# APPLICATION

PERCOLATION TESTING

**HOUSE LOCATION DRAWING**

TO: CRAIG WILLIAMS DESK SAN  
FROM: JIM SELFRIDGE  
SUBJECT: RIDGE VIEW HUNT - LOT 3 PERC REVISION  
DATE: 7/22/98

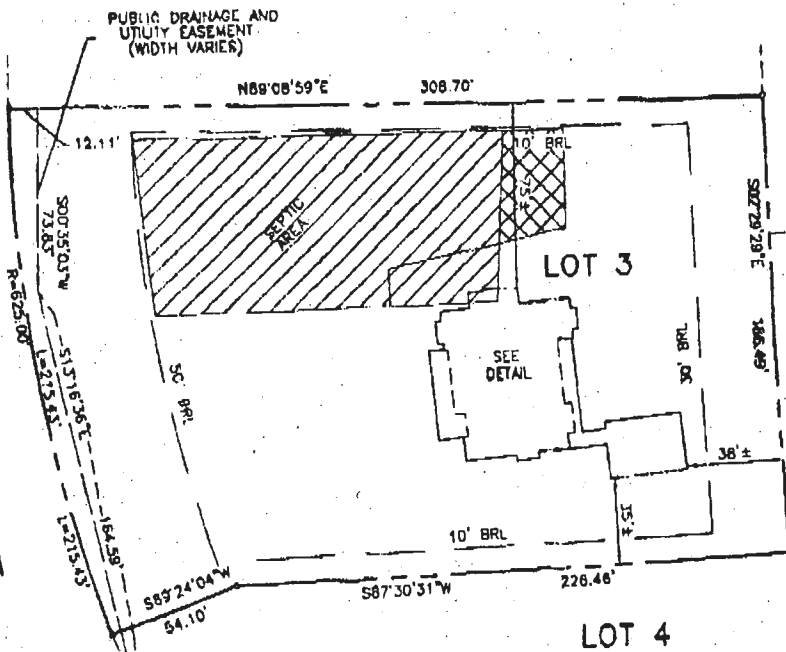
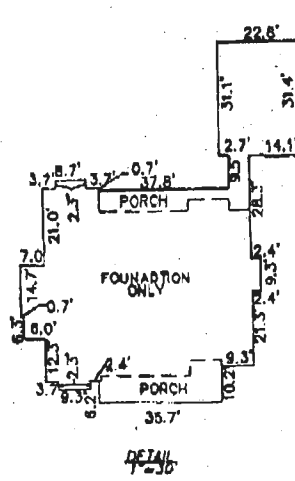
HOUSE SEEMS TO  
HAVE MOVED ~3' TOWARDS  
SEPTIC AREA,  
SPECS ADJUSTED - OK  
MR

(2) REVISED PERC EASEMENT

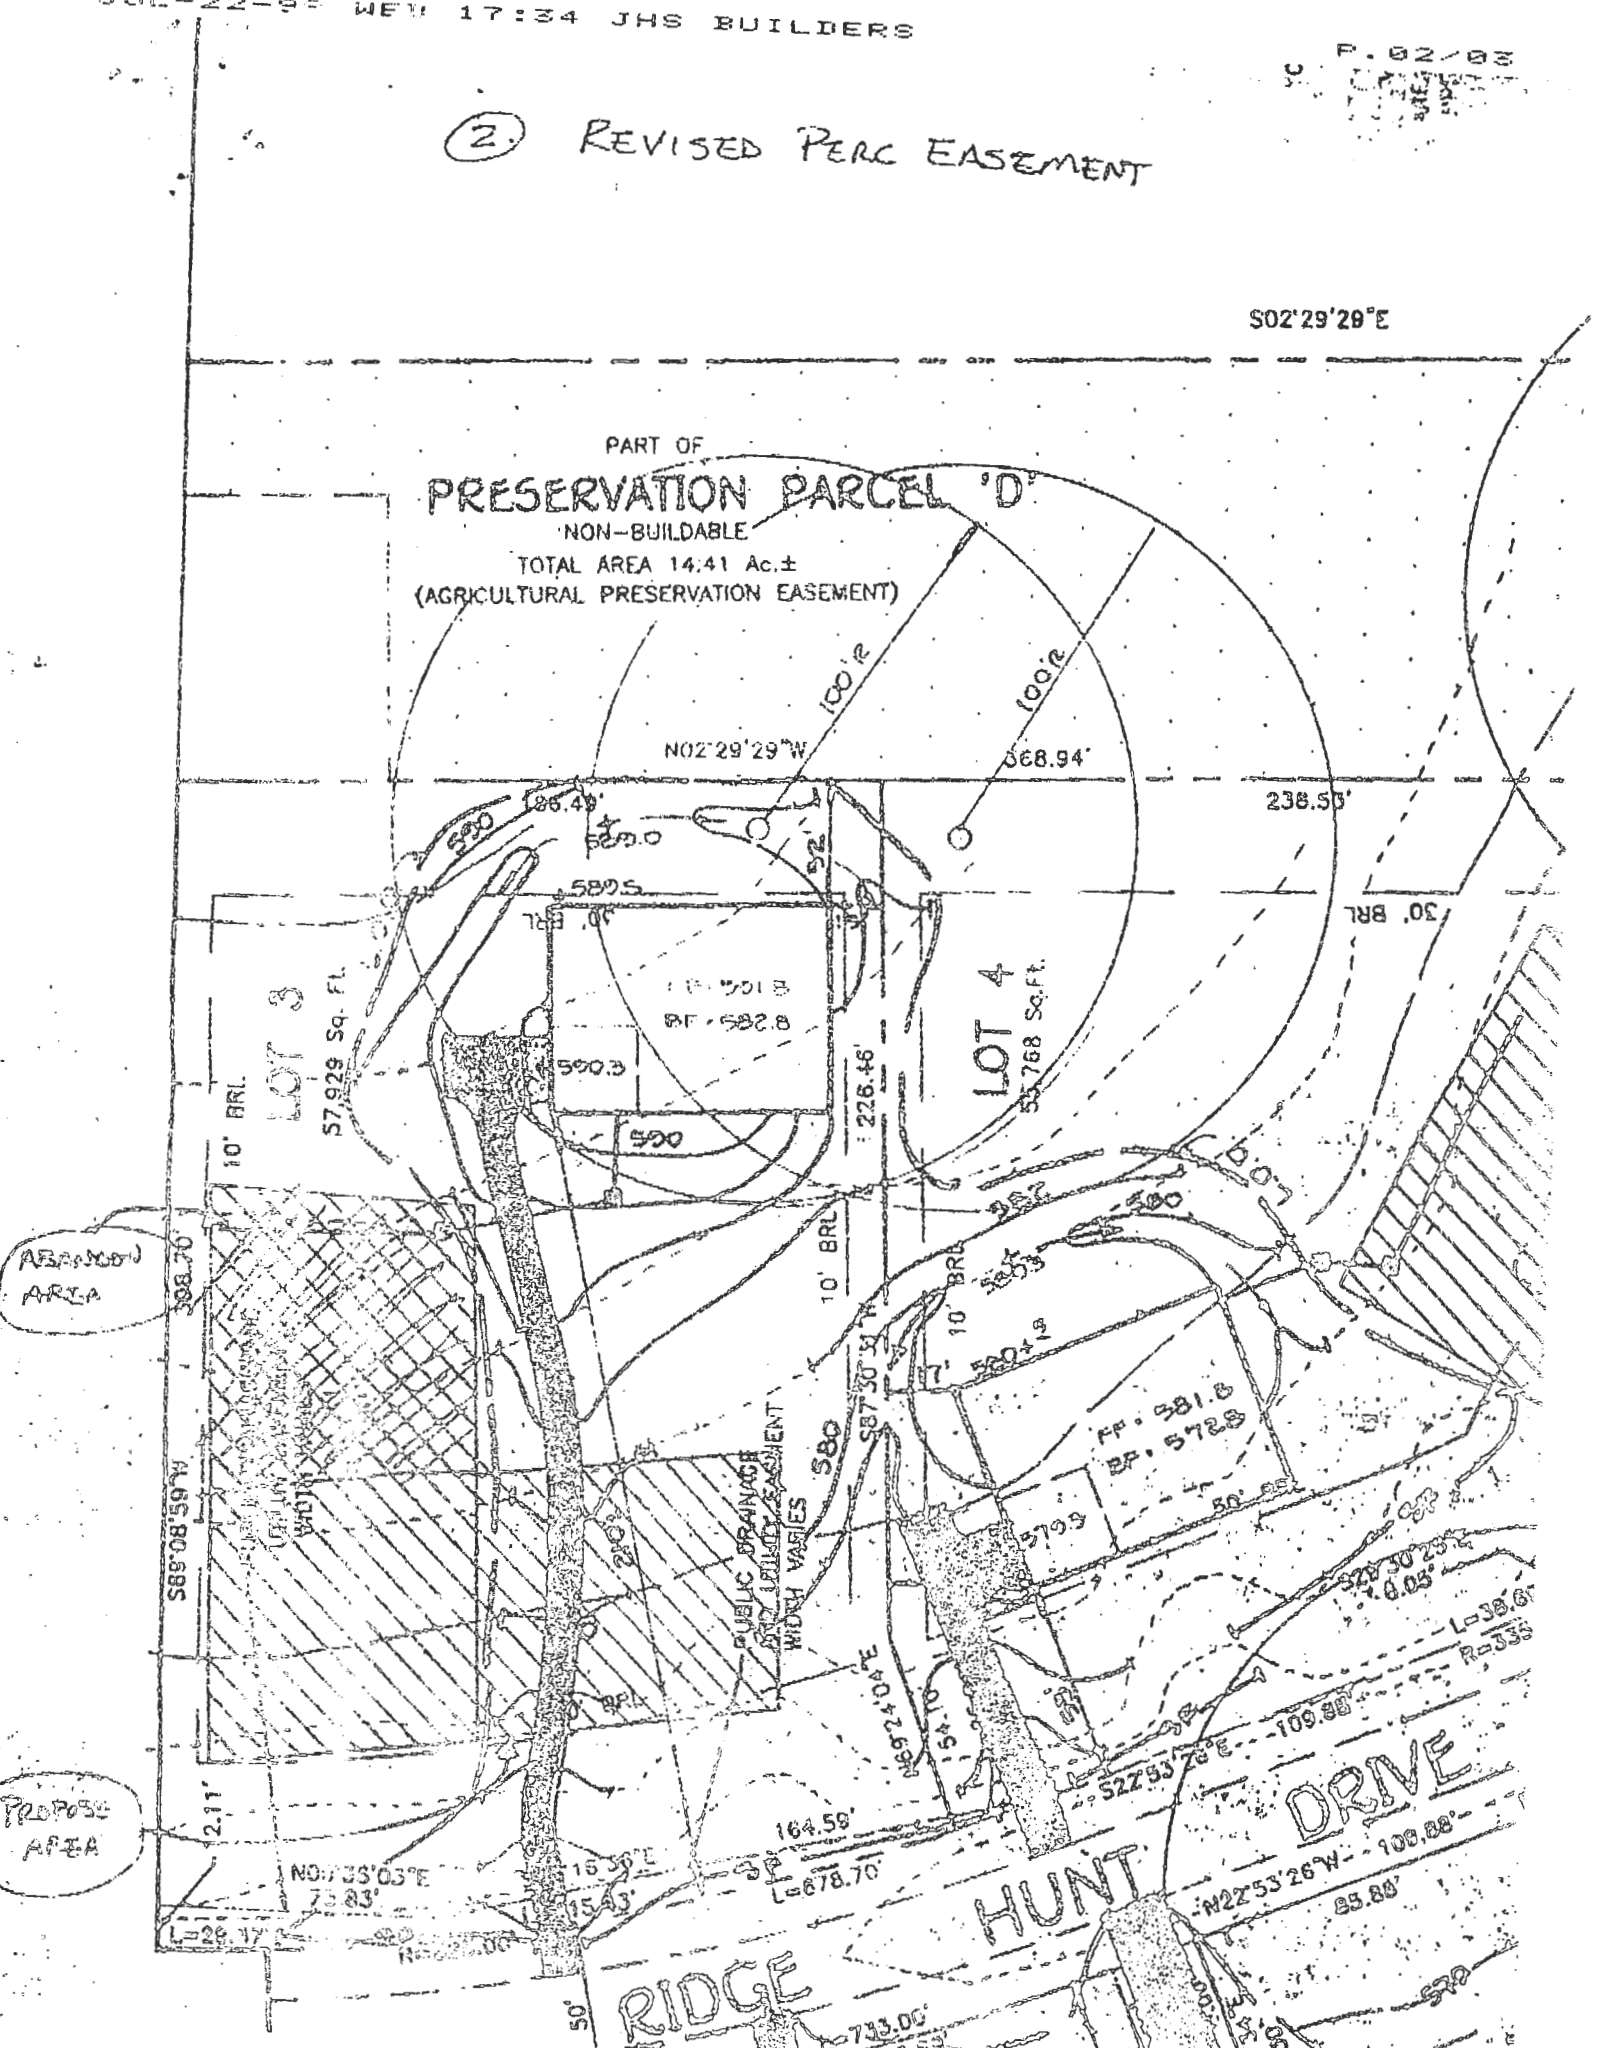
ADDITIONAL INFORMATION: CRAIG -- IS THIS ENOUGH  
INFORMATION TO REQUEST A PERC TEST TO CHANGE  
THE EASEMENT? IF NOT PLEASE LET ME KNOW.  
I WILL HAVE THE EASEMENT REVISION CERTIFIED BY  
OUR ENGINEER ON THE PLOT PLAN WHEN WE SUBMIT  
FOR A BUILDING PERMIT. ANY QUESTIONS  
PLEASE GIVE ME A CALL.

PERALM,  
ABSOLUTELY  
NO SDA ADJMENT  
ALLOWED

ADVISED OF TWO TEST  
HOLES INVICINITY OF  
PROP ADJUSTMENT (ONLY 1 OF  
WHICH PASSED) & CONCERN  
OF WELLS DOWNSLOPE ON LOTS 12 + 13
